**FINDINGS AND RECOMMENDATION
OFFICE OF PLANNING AND ZONING
ANNE ARUNDEL COUNTY, MARYLAND**

CASE NUMBER: 2023-0191-V

REQUEST

VEILLEUX
 2387 DAVIDSONVILLE, RD.
 GAMBRILLS, MD. 21054
 2000-0158-8500
 R-A

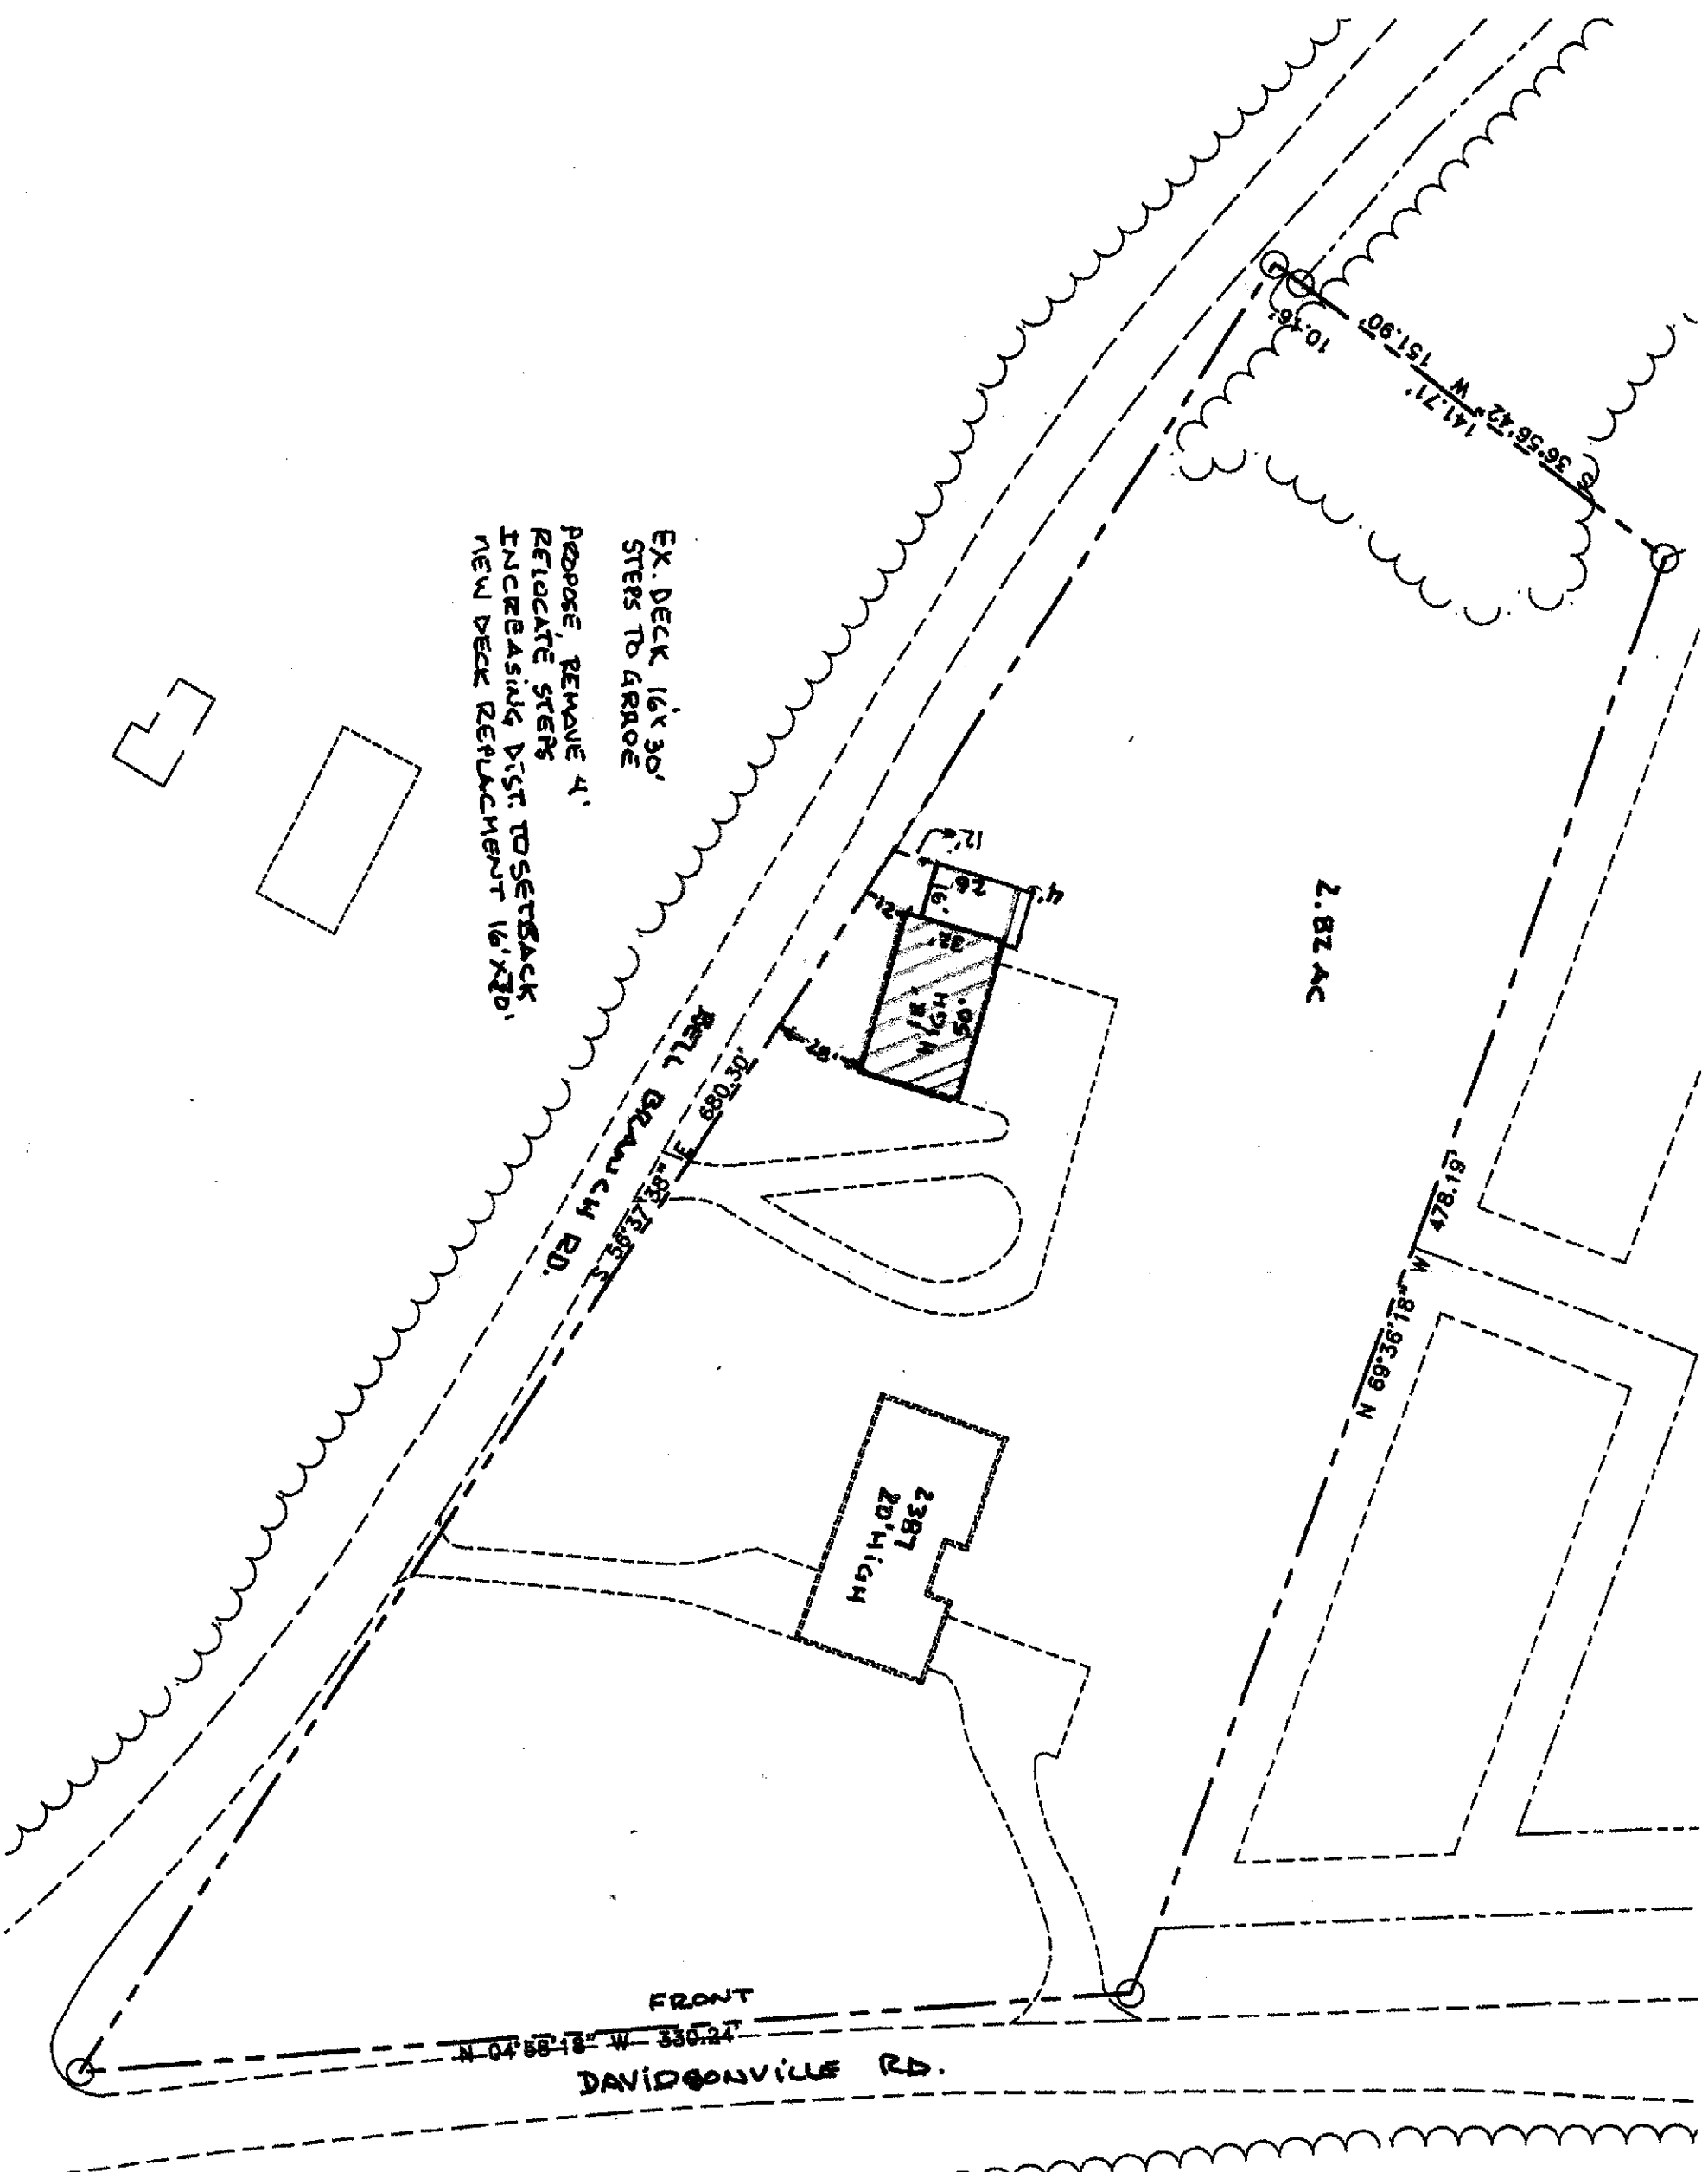
In addition, the applicants are requesting a variance to allow the unpermitted deck to remain. As shown on their revised site plan, they are proposing to reduce the length of the as-built deck and to relocate the steps to grade in order to keep the deck in line with the existing barn's 28 foot encroachment into the corner side lot line setback.

With regards to the unpermitted second story deck, the applicant has proposed to reduce the size of the deck, and to relocate the steps to grade, so that it will be in line with the existing barn. However, there will still be increased structural encroachment into the corner side setback. A set of stairs to the upper level of the barn had been removed to construct the deck. The applicants offered no justification as to why such a large deck is needed to access an area proposed as storage. Nor have they offered justification as to why it could not be constructed in another location, such as along the western or southern side of the barn, which would not require a variance.
